I am to advise you that the Agency has initiated a review of a Waste Licence held by KTK Landfill Limited on 31/08/10, for a facility located at KTK Landfill Limited, Brownstown and Carnalway, Kilcullen, Co. Kildare.

**RE: Leachate Treatment**

**PROPOSAL FOR SPECIFIED ENGINEERING WORKS:  
KTK LANDFILL, KILCULLEN, CO. KILDARE.  
WASTE LICENCE W0081-03**

**Installation of Leachate Management Infrastructure**

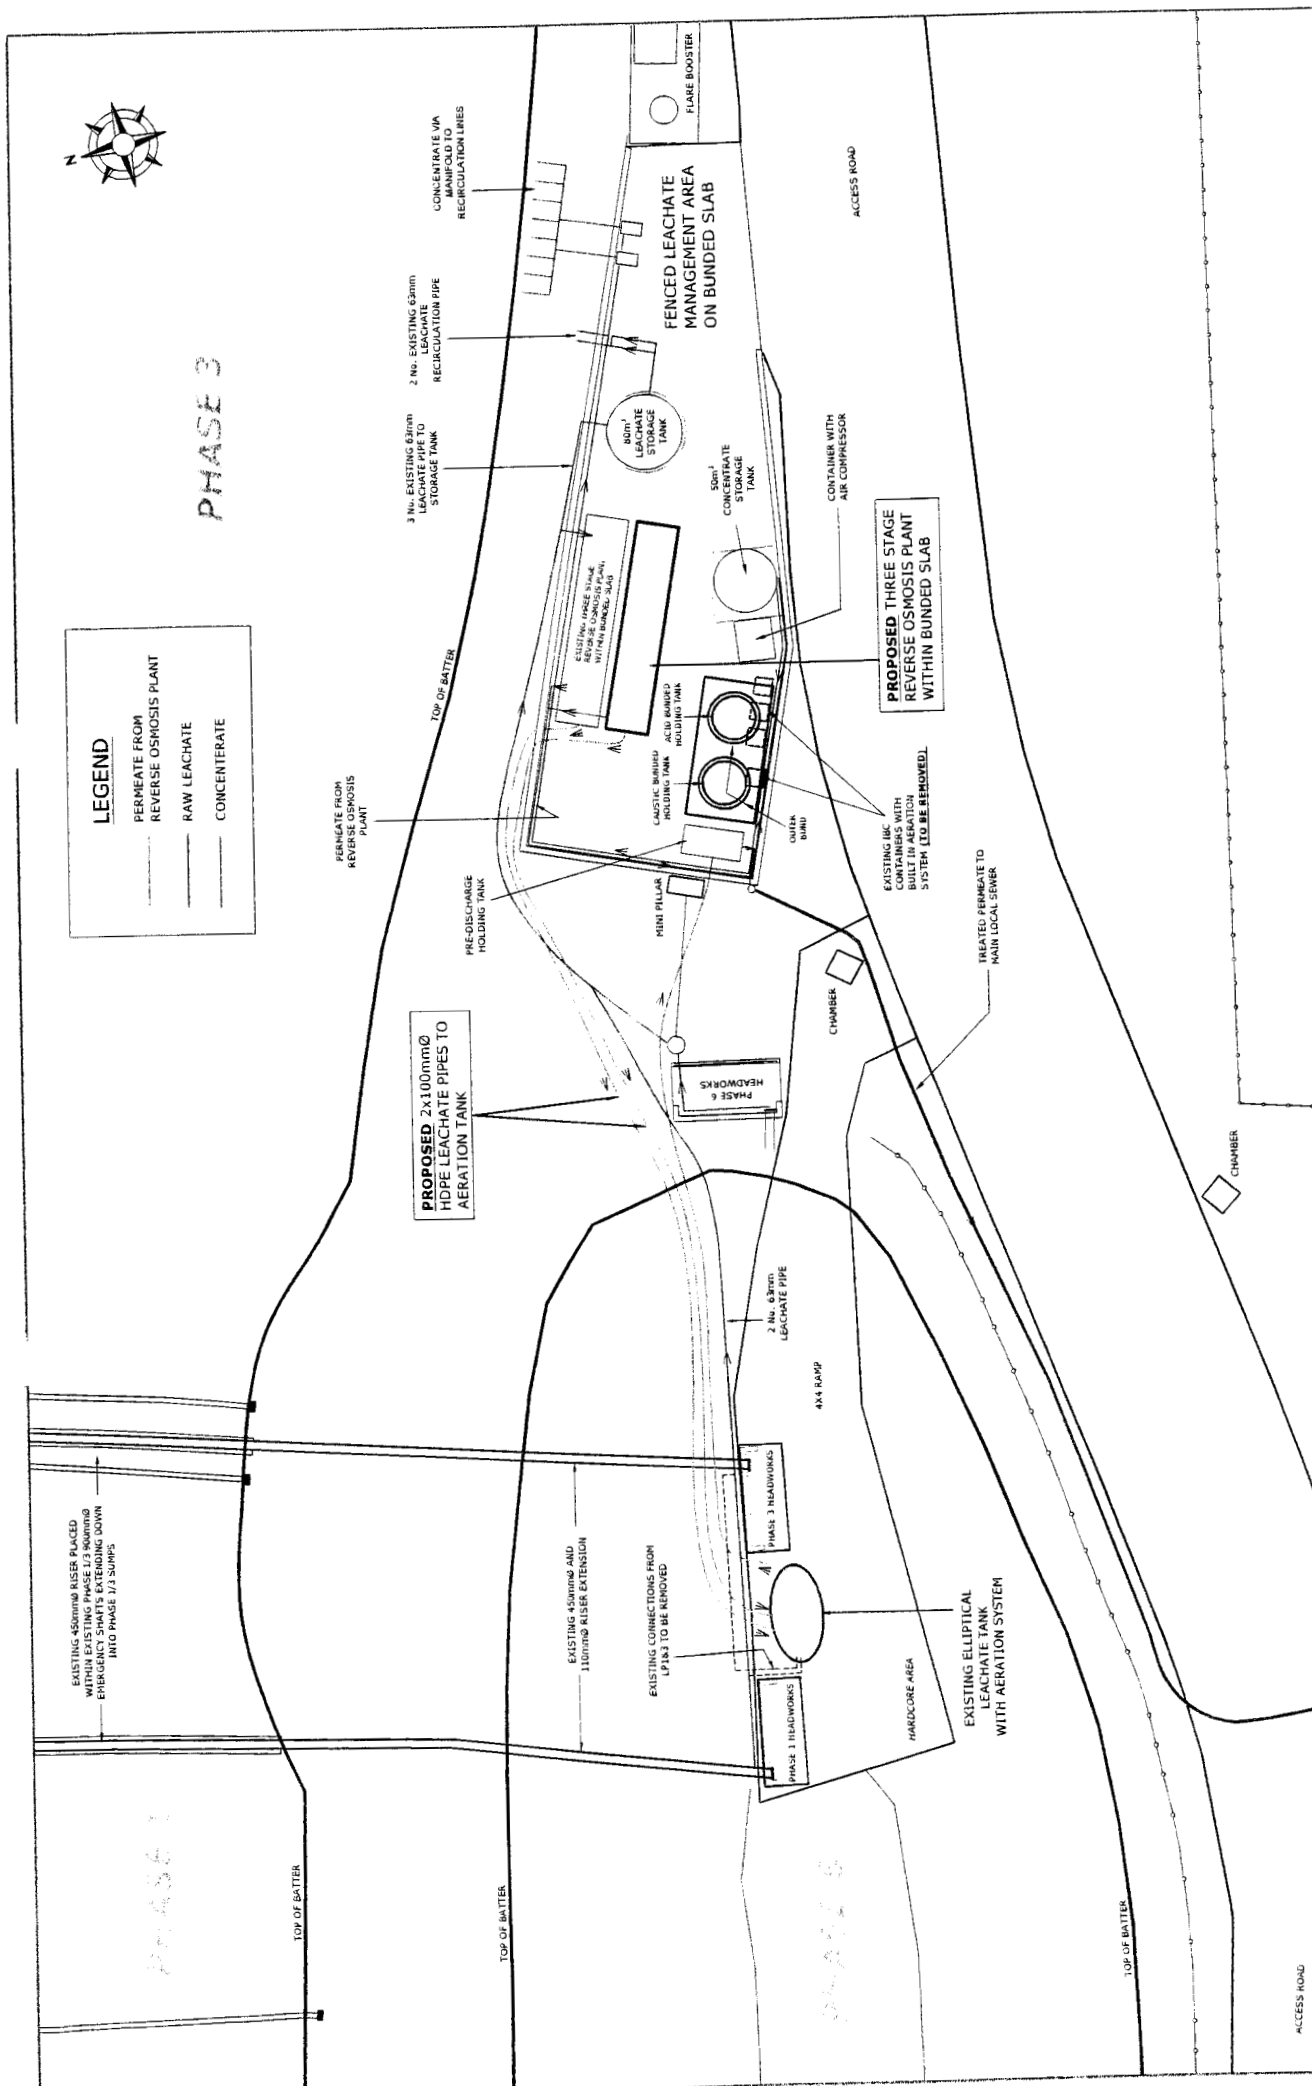
2. The network of wells (GW208, GW75, GW41, GW79, GW100, GW224, GW86, GW187, GW197, GW128 and GW 231 as set out in Figure RO 02/01 "*Leachate and Concentrate Re-Infiltration System*") shall be adapted as set out in Section 4.2.2 and dipped for leachate level as proposed. This should be done on a monthly basis for the first three months post this correspondence and quarterly thereafter. A separate report on the first months monitoring should be submitted to the Agency and shall include borehole drilling/constructions logs and appropriate cross-sections and schematics demonstrating their construction in relation to the base of the landfill and the landfill surface. A minimum of a weekly level measurement reading for leachate sumps LP1, LP3 and LP6 shall also be reported in the Quarterly Reports.
